Our ref: HGY/2025/0101 Contact: Valerie Okeiyi Date: 03/02/2026
Town and Country Act 1990 (As amended)		
Location:	Hornsey Police Station, 98 Tottenham Lane, Hornsey, London, N8 7EJ	
Proposal:	Approval of details pursuant to condition 27 (Overheating Report) attached to planning permission HGY/2022/2116	
Wording of condition c27:	Prior to the above ground commencement of the development, an updated Overheating Report shall be submitted to and approved by the Local Planning Authority to confirm the overheating mitigation strategy in the Overheating Assessment prepared by Create Consulting Engineers (dated July 2023) that has been approved in principle. This report shall include: - Updated modelling of units modelled based on CIBSE TM59, using the CIBSE TM49 London Weather Centre files for the DSY1-3 (2020s) and DSY1 2050s and 2080s, high emissions, 50% percentile; - Confirmation on which windows the external shutters will be installed; - Demonstrating the mandatory pass for DSY1 2020s can be achieved following the Cooling Hierarchy with external shutters and in compliance with Building Regulations Part O, demonstrating that any risk of crime, noise and air quality issues are mitigat

Figure 3.5: External Blind assigned for Bedrooms (South Elevation)

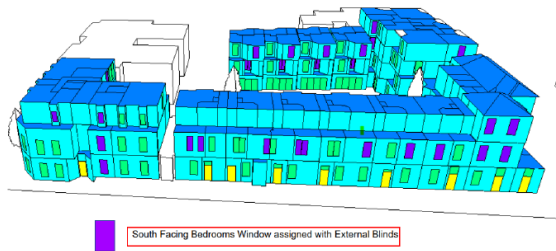
In the approved planning scheme, the following windows have been approved with external blinds:

- The number of windows provided with external blinds has been significantly reduced from the approved planning scheme. Please can applicant justify the reason and to confirm that additional windows will be installed with external blinds. The submission does not currently align with the requirements of the planning condition.
- Applicant to provide a window head detail to show how the external blind would be installed.
